#### MEMORANDUM

TITLE: PUBLIC HEARING and consideration of the postponement request

regarding a Subdivision Permit & Plat for Meadowlark Airpark, located at Govt. Lots 1, 2, 3, and 4 less a portion, and all of the NW1/4 SE1/4 less a

Jones Land Surveying, Inc., on behalf of Phillip and Marium Trefren of 3660 Road 215, has submitted a Subdivision Permit and Plat application for Meadowlark Airpark located southwest of the intersection of Road 137 and Aviator Court. The application has been submitted for the purpose of subdividing four parcels into 27 residential-use tracts.

> FINAL PLAT FOR

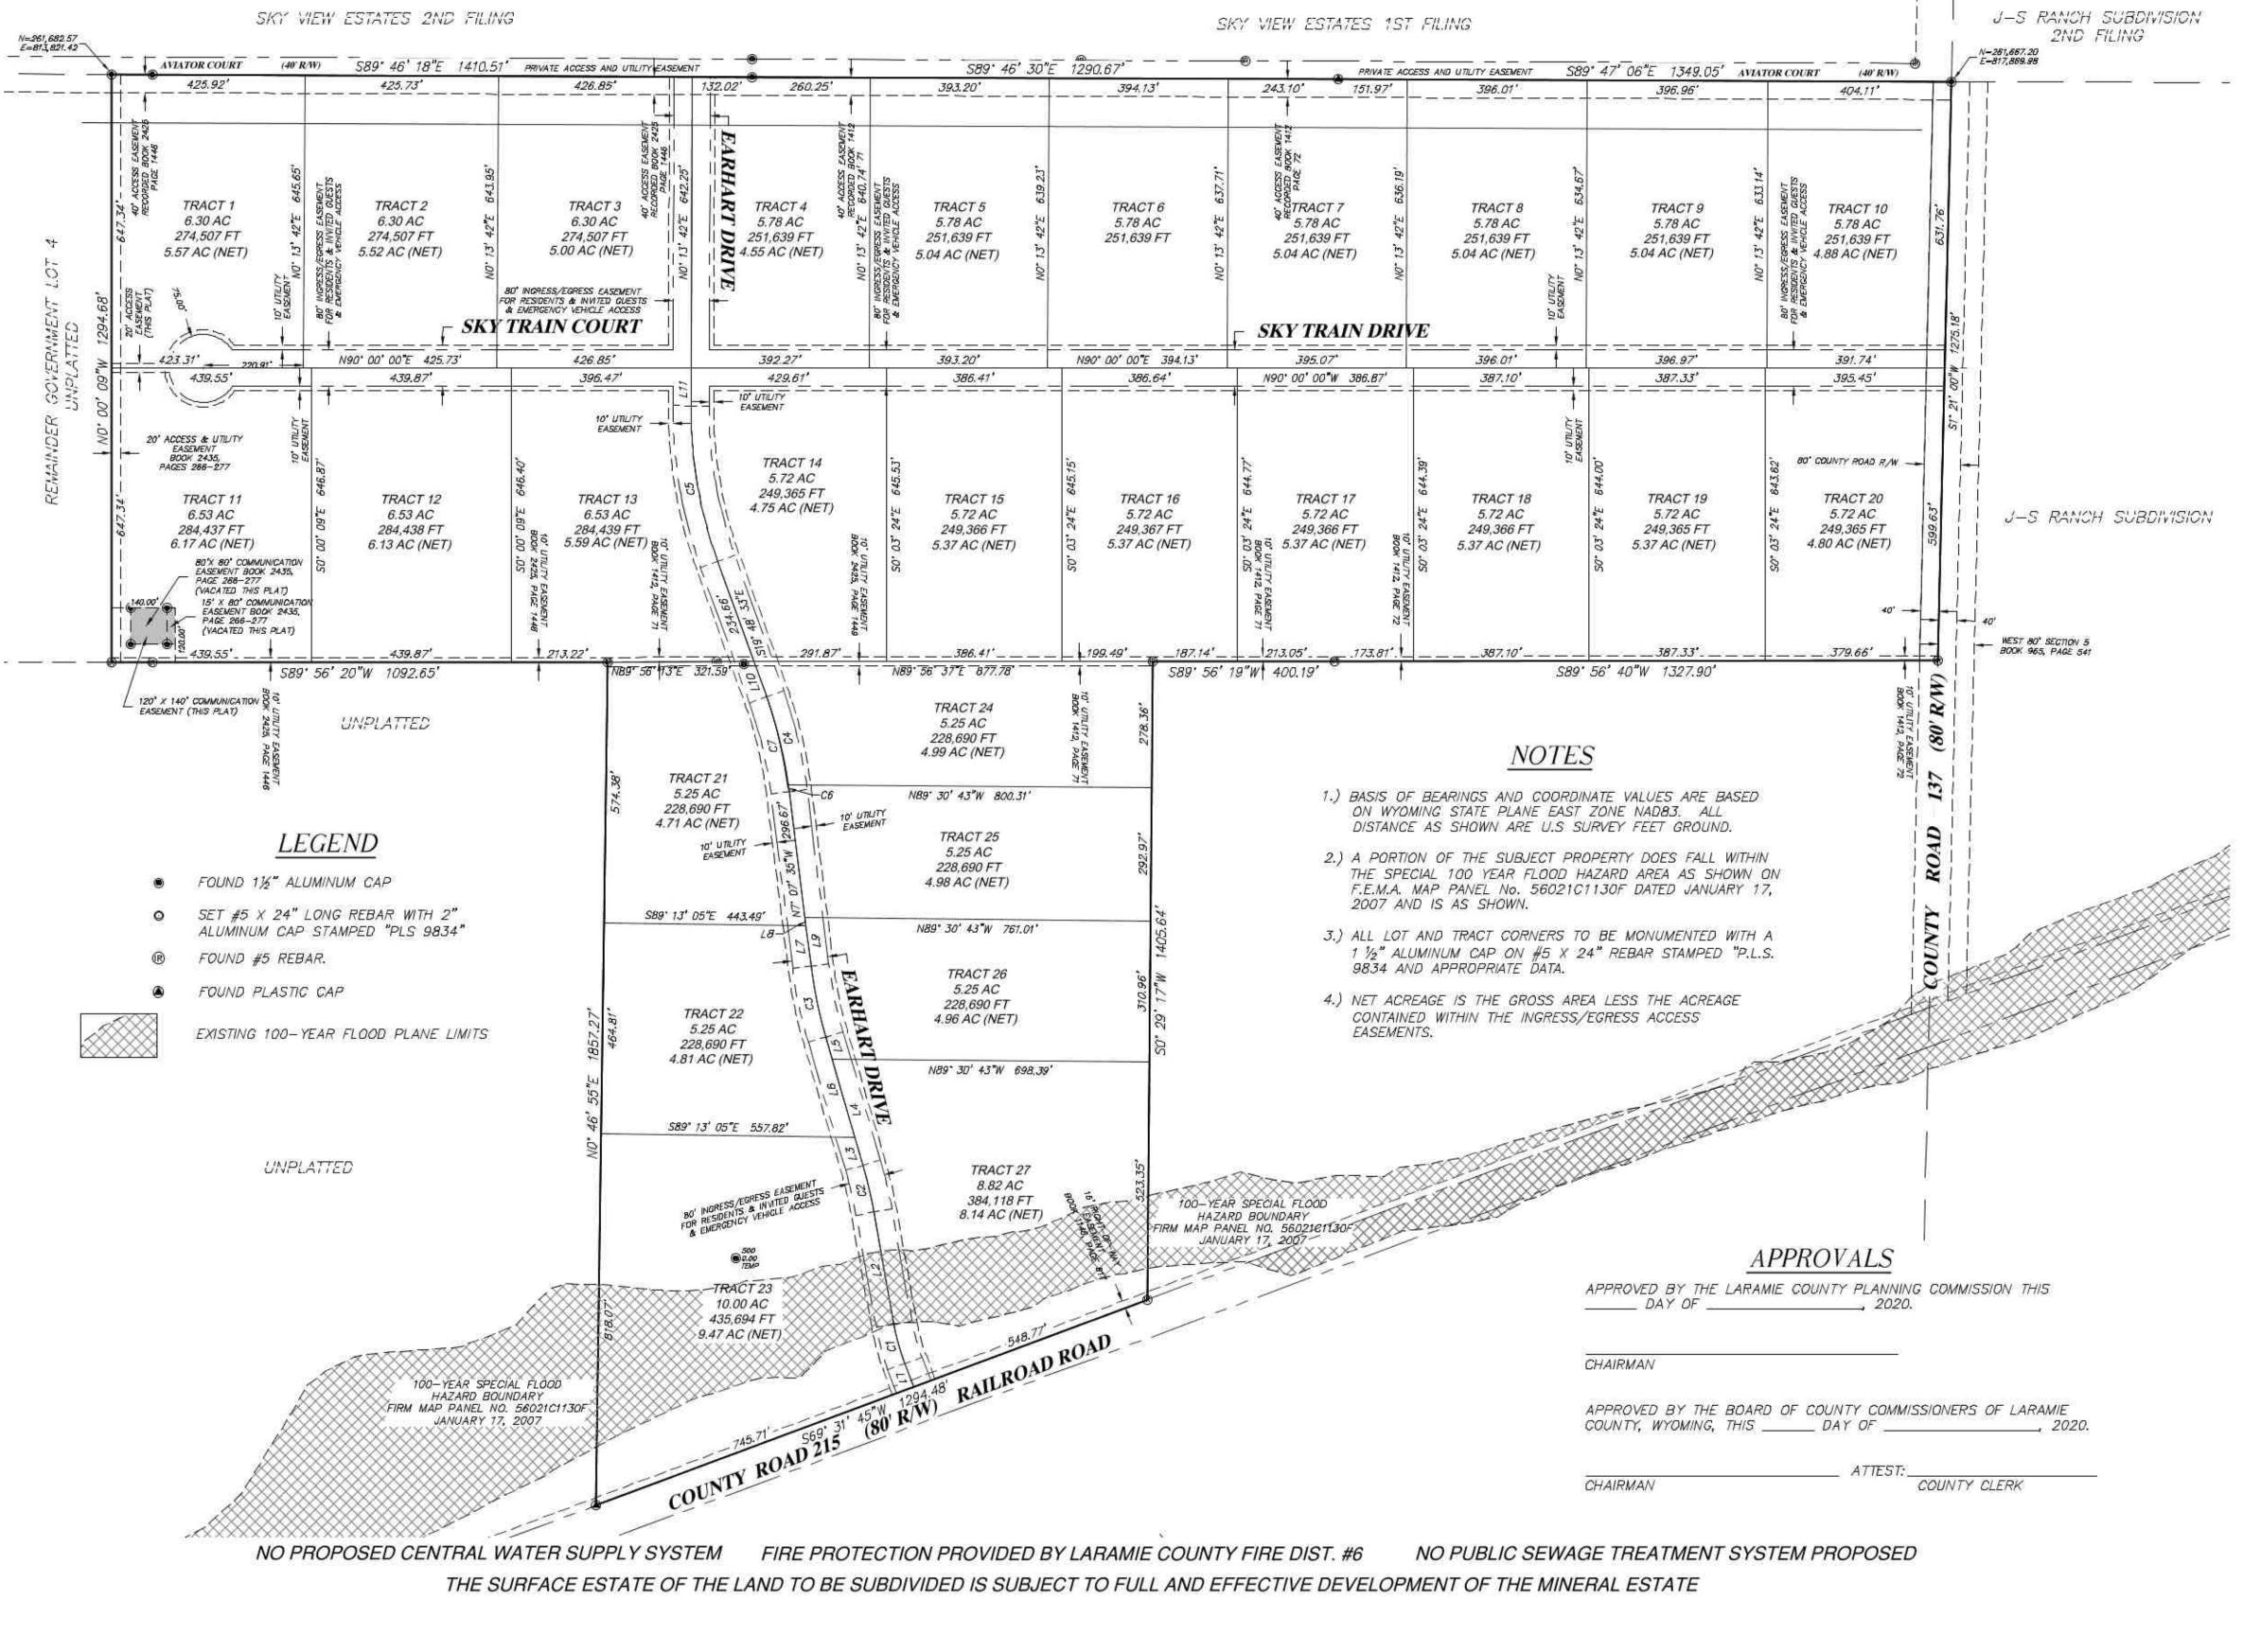
<u>County Assessor:</u> County Assessor, Kaycee Eisele Comments Attached 12/28/2020 In the title block, Airpark is one word, which is what our records will reflect but in the dedication it is 2 words.

- 4. The Curve Table on the plat does not show the information for C6 and C7 that are called out on the drawing.
- 5. The Line Table on the plat does not show the information for L10 and L11 that are called out on the drawing.

- 6. The dates on the plat for approvals show 2020 and these should be changed to 2021.

1. In the first line of the last paragraph of the DEDICATION "HAS" should be "HAVE", in the second line of the same paragraph "THERE" should be "THEIR" and in the third line of the same paragraph "THERE" should be "THEIR".

- 2. The dimension arrow indicating the north boundary of SKY TRAIN COURT, shown along the south boundary of TRACT 2, is drawn/connected to the north boundary of the 10' UTILITY EASEMENT, not to the north boundary of SKY TRAIN COURT.
- 3. Along the east boundary of TRACT 4, the text identifying the 40' ACCESS EASEMENT is overlapping the dimension of the east boundary of TRACT 4.
- 4. What is the purpose/function of the "WEST 80' SECTION 5-BOOK 955, PAGE 541" labeled east of the southeast corner of TRACT 20?

- 1. In the first and fourth paragraphs of the dedication, the subdivision is referred to as "Meadowlark Air Park", but in the title is referred to "Meadowlark Airpark". Please revise.
- 2. The third paragraph of the dedication should also be updated to say "Said parcels" not "Said parcel".
- 3. The approval blocks must be placed directly next to the right or bottom border of the plat.
- 4. Approval Dates in the signature blocks must be updated to read 2021 rather than

- 5. Please label the property directly to the east of proposed tracts 24-27 as unplatted for continuity purposes.
- 6. Please add a note stated that the proposed roads will be privately maintained and will not be maintained by Laramie County.
- 7. Please update the Curve and Line Tables to show all Curve #'s and Line #'s as some are missing.
- 8. The acknowledgments signatures block will be signed in 2021, please update year.
- 9. The Wyoming DEQ Chapter 23 Study for this subdivision must be submitted prior to approval.
